February 5, 2002  
NRC:02:011

### **Responses to an Informal Request for Supporting Information**

INFORMATION NEEDED FOR CFL BREAK REVIEW, TAC MA9973

FIGURE 2

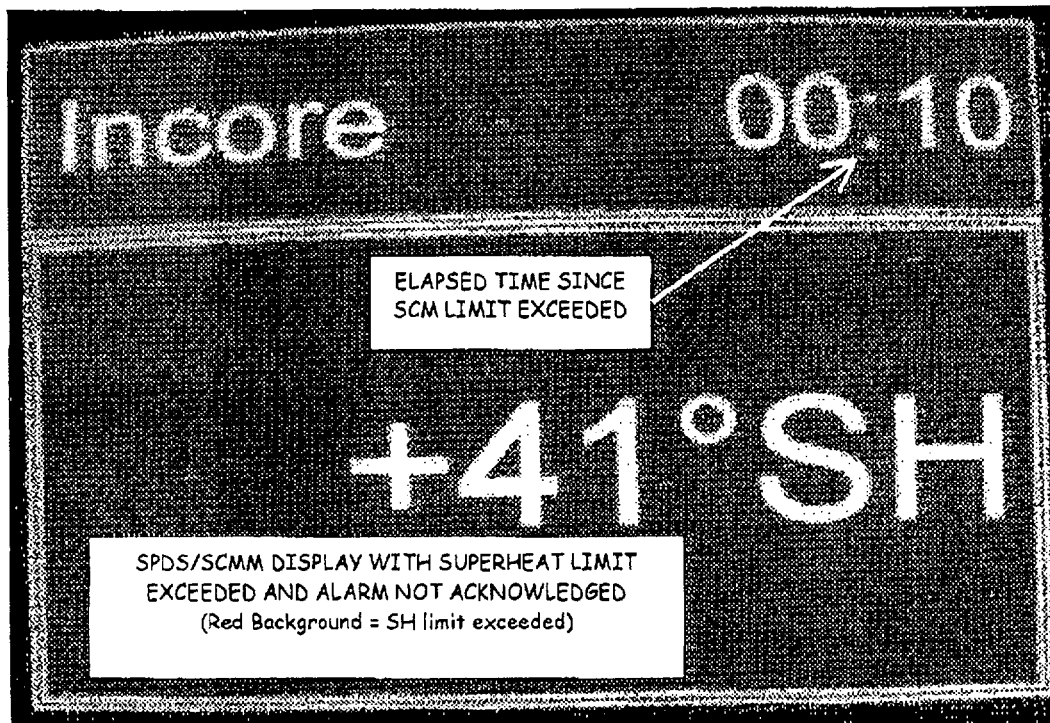
- 2. Identify the information needed by the operators and describe how the information is provided visually and audibly. Address the safety “pedigree” of the applicable displays and describe alternates, including operator response, if the primary information sources are lost. Include photographs of the key visual information sources.**

Normally, the Subcooling Margin Monitor is displayed in the area at the top of the SPDS display. When not in alarm, the Subcooling Margin is displayed as black characters on a green background (see Figure 2).
